11.1 & 11.2 Bankhead Drive, Bankhead Avenue and South Gyle Access Walk and Cycle Improvements

Consultation Summary Report

February 2017

Figure 1 South Gyle Access proposals (1 of 4)

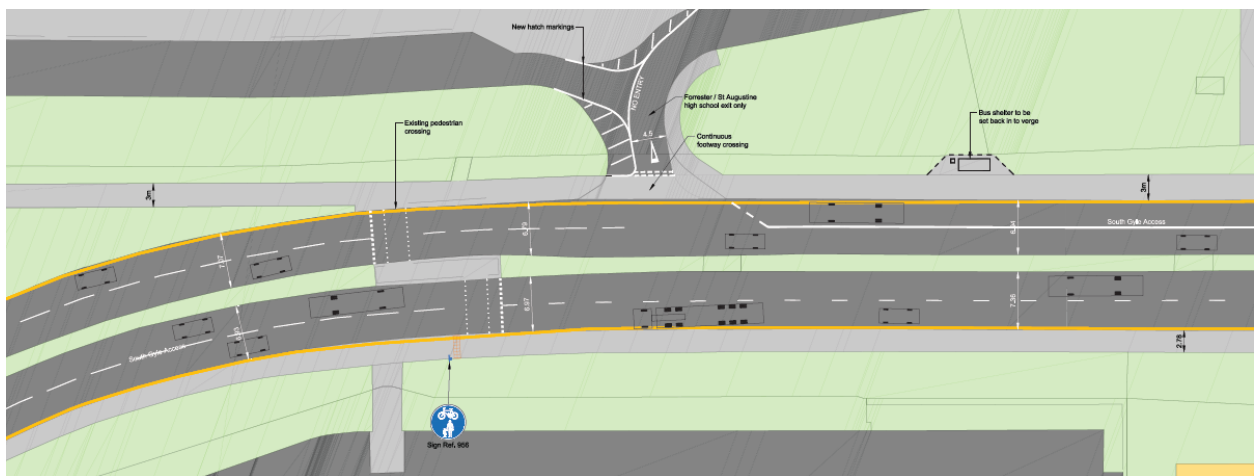
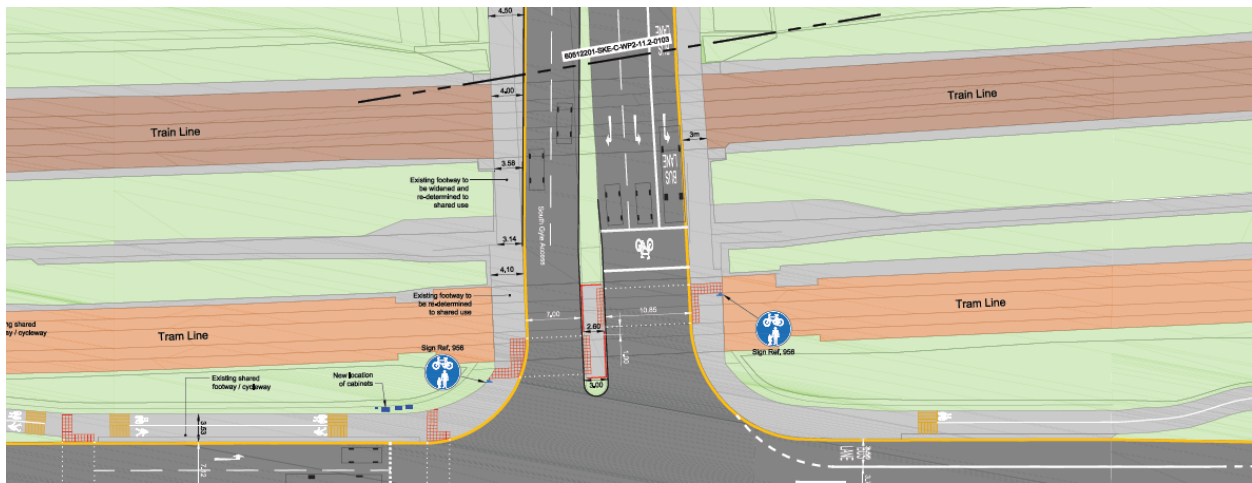
- 1 A single stage crossing should be adopted at the southern end of South Gyle Access. This will provide a direct crossing, with reduced delay to pedestrians and cyclists (10)

- 2 The staggered crossing at the southern end of South Gyle Access should be widened/ redesigned as there is insufficient space for cyclists to pass safely (3)

| 34 | Neither support or oppose | <p>- One of the main problem locations on Quiet Route 8 is the crossing of South Gyle Access. It is an extremely poor crossing for people on bikes and poor for people walking too. It is VERY disappointing that no improvements are planned here. - The staggered</p> | <p>The refuge island on South Gyle Access will be widened as part of this scheme (this is shown on the design drawings). Further widening was assessed but was not proposed as this would create significant delays, including to several bus services.</p> <p>Similarly, a single stage crossing was considered but not taken forward as this would also create significant delays, including to several bus services.</p> |

Figure 6 Bankhead Avenue proposals

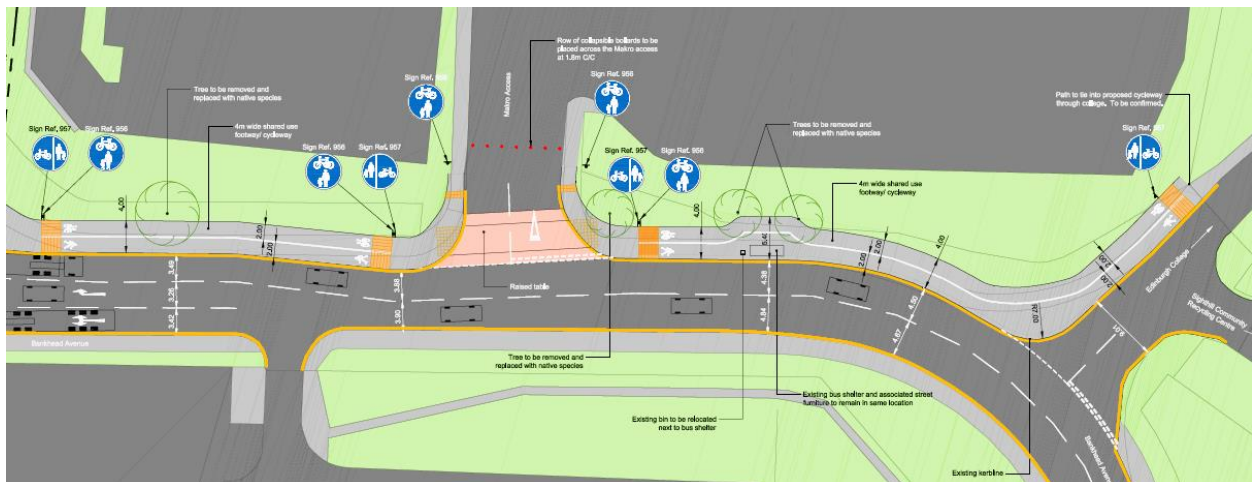
- 1 A continuous footway should be used at the Makro access to provide priority to pedestrians and cyclists (3)
- 2 It will need to be made clear which areas of the shared footway/cycleway are for pedestrians and which are for cyclists (1)

- 3 The bend radii need to be tightened on the Makro access to prevent vehicles turning in/out too fast (1)

| Ref I.D. | Support for proposals | Can you briefly explain your view on the last question? | Council Response |
|----------|-----------------------|--|---|
| 38 | Strongly support | Mostly OK, but the bend radii need to be tightened on the Makro access to prevent vehicles turning in/out too fast. Adequate priority needs to be given to the pedestrian/bike crossings of Bankhead Dr/Bankhead Ave. - this could be a separate phase of the lights, allowing crossing in all directions at once, with a rapid response on button-push. | We shall re-assess whether corner radii at Makro can be tightened, however access by HGV's may prevent this. |
| 25 | Support | There are too many two stage crossings. Every single one of these should be replaced by a single stage crossing. The entrance/exit to Macro should have its give way line set back behind the path to ensure the correct priority as per South Gyle Access plans. | More single stage crossings were considered. At South Gyle Access it was not possible as this would create significant delays, including to several bus services. |

| 40 | Neither support or oppose | You need to change traffic sequences to favour pedestrians and bicycles. Also, who will have right of way over the entrance to Makro? Surely it should be the bicycle & pedestrian as an element of vulnerability, so you need signage on the | The proposed single stage crossing will improve crossing facilities for pedestrians and cyclists. We shall consider a continuous footway at Makro, |

A raised table crossing has been included at Makro and we shall consider whether a continuous footway treatment could be introduced.

| | | | The current proposal includes a single stage crossing of Bankhead Drive at Bankhead Avenue. This is positioned on the optimum pedestrian desire line (to the college and tram stop and uses the fewest crossings). Based on available budgets and the relatively low pedestrian benefit we are not intending to change other crossings at this location to direct single stage crossings. |
